## **Alert Requirements Bulletin B787-81205-SB720007-00 RB ENGINE (TRENT 1000 ENGINES) - Interservices Fairings - Thrust Reverser Upper Splitter Fairing Assembly Change**

**Task 1 – ENGINE - UPPER SPLITTER FAIRING ASSEMBLY - REPLACEMENT**  
**[Group 1:]**

*Figure 1*

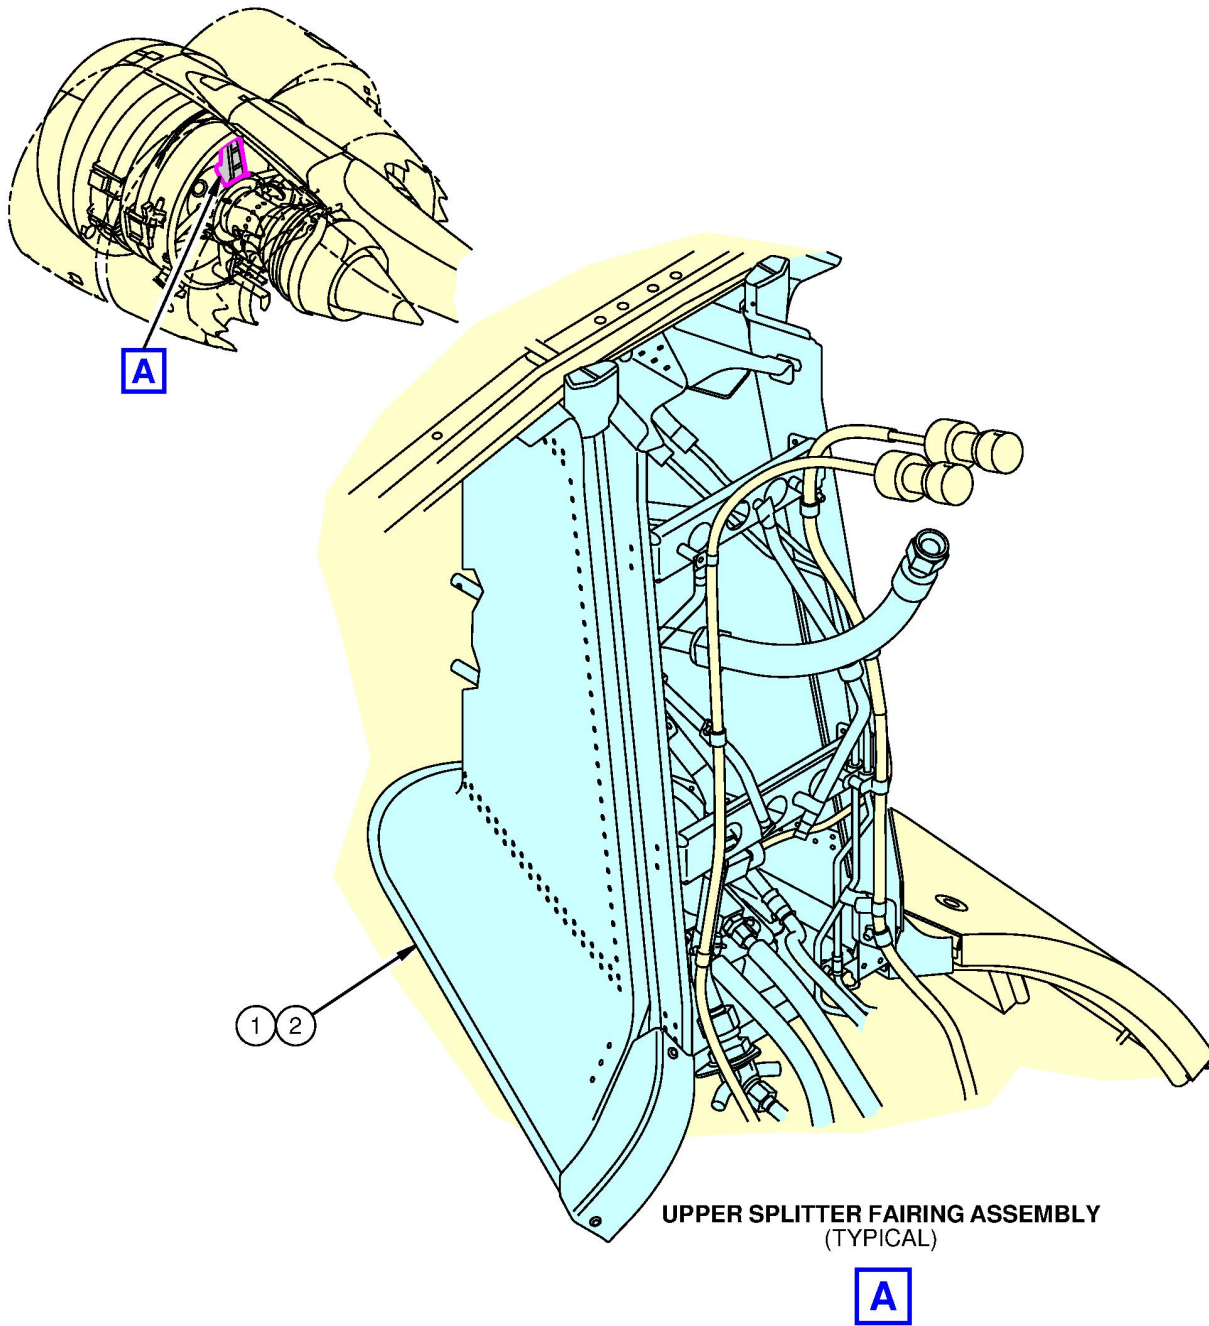
Step	Action	Name	Identification	Qty	More Data
1	Remove	UPPER SPLITTER FAIRING ASSEMBLY	-	1	*[1]
2	Install (New)	UPPER SPLITTER FAIRING ASSEMBLY	-	1	*[1]

\*[1] Replace existing Upper Splitter Fairing Assembly with new Upper Splitter Fairing Assembly in accordance with Rolls Royce Service Bulletin TRENT 1000 72-AK759, Initial Issue, dated Jul. 28/22.
